SHOP DRAWING TRANSMITTAL

CHA PROJECT No.20615 CONTRACT No. BRF 3000(19) TITLE: RUTLAND CITY (RIPLEY ROAD)	
---	--

Topic BRF3000 (19) Expansion Joint Shop Drawings - Ripley Road
Status For Approval

Subject: Expansion Joint Shop Drawings for Approval 1 Set Electronic

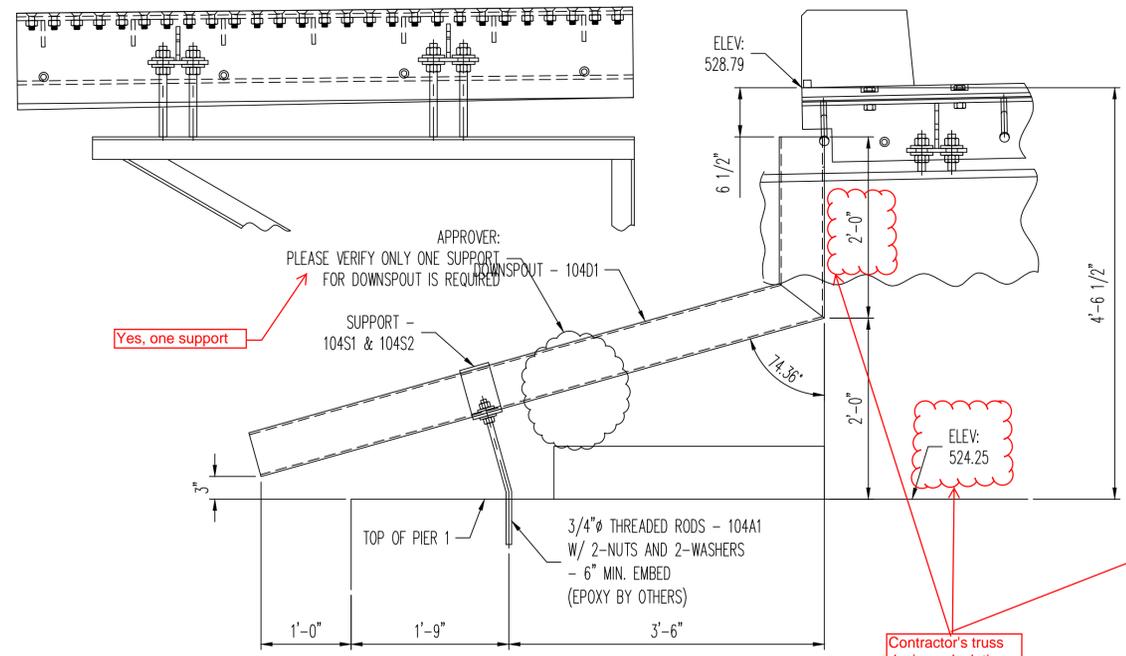
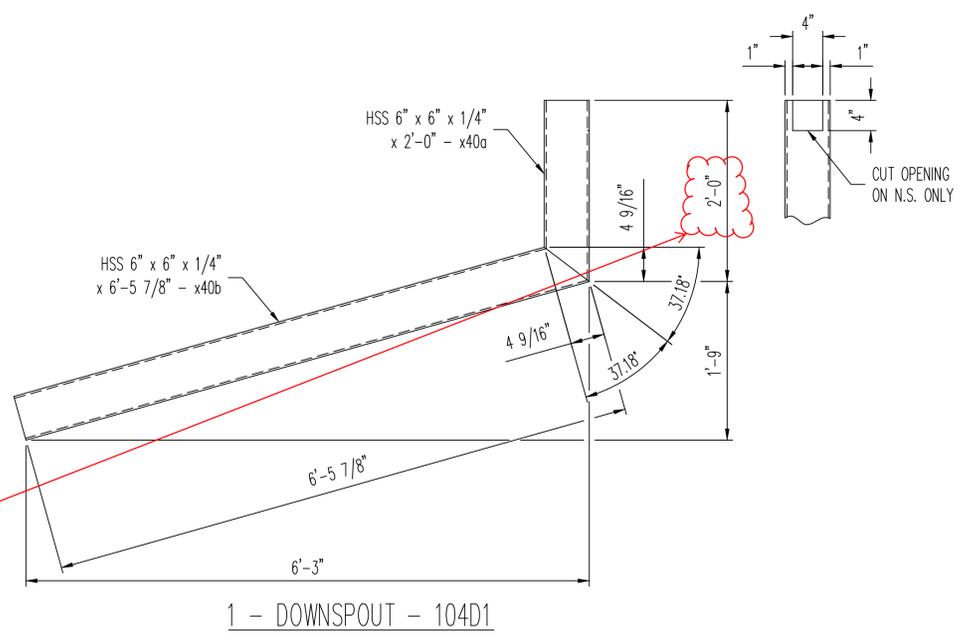
Contractor's truss design calculations show revised top of pier elevation as 523.70. Please confirm with Contractor the correct elevation and revise dimensions and downspout as necessary.
